## 6C Containment Debris Protection for ECCS Strainers

STD DEP 6C-1 (Figure 6C-1, ~~6C-2, 6C-3, 6C-4, 6C-5~~)

STD DEP Vendor

Figure 6C-1 Cassette Strainer Cutaway

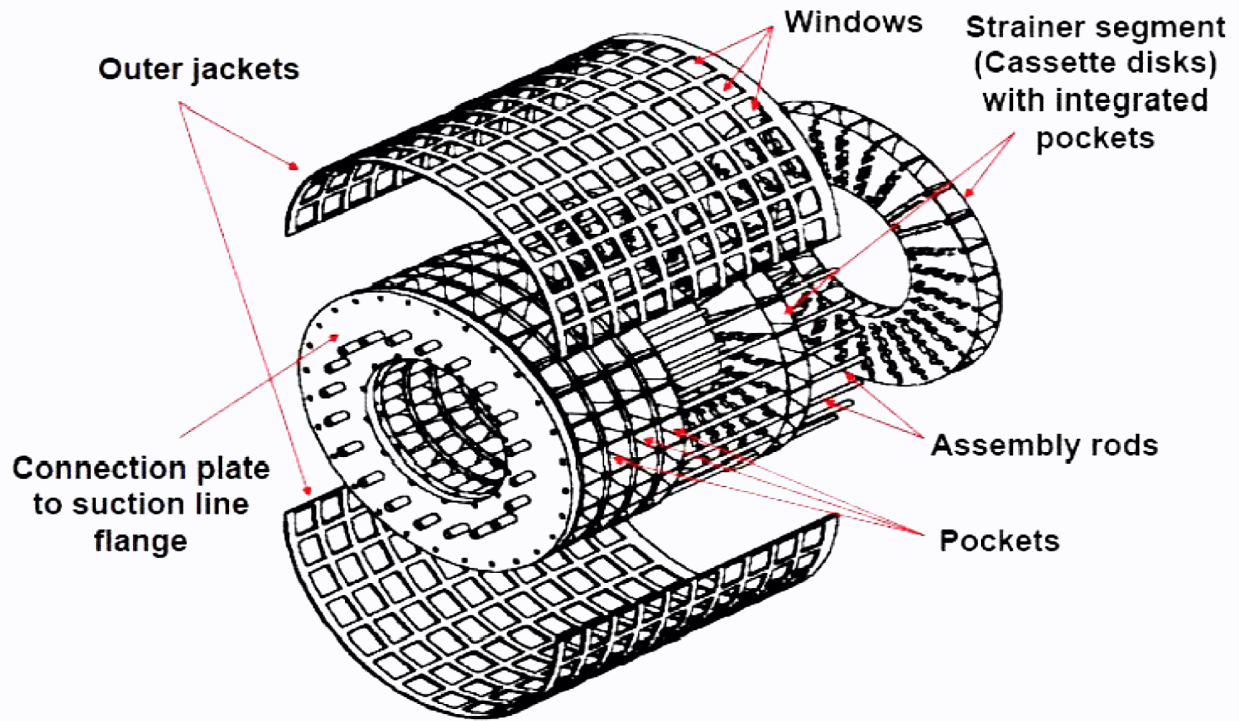
The information in this appendix of the reference ABWR DCD is subject to several changes due to the adoption of a complex ECCS strainer design (e.g. Cassette Type Strainer). Consequently, for clarity it is presented in its entirety with the following departures incorporated. This strainer design has been used at numerous BWRs in Japan and numerous PWRs in the United States. The strainer is described in this appendix. Departure STD DEP Vendor changes General Electric (GE) to Toshiba in Section 6C.1.

- (7) ~~The ECCS suction strainers~~ The complex cassette-type ECCS strainers meet the current regulatory requirements unlike the strainers at the incident plants.

Each loop of an ECCS system has a single pair of suppression pool suction strainer configured in a T shape with ~~a screen region~~ the strainers at the two ends of the T cross member. Analysis determined the area of each ~~screen region~~ strainer. Thus, RHR with three loops has six ~~screen regions~~ strainers. The HPCF with two loops has four ~~screen regions~~ strainers, and the RCIC has two ~~screen regions~~ strainers. ~~The characteristic dimension given for the screens in the results below indicates a surface area consisting of a circle with a diameter of the dimension plus a cylinder with a diameter and length of the dimension.~~ The characteristic dimensions to calculate a surface area for cassette type strainer are given as follows.
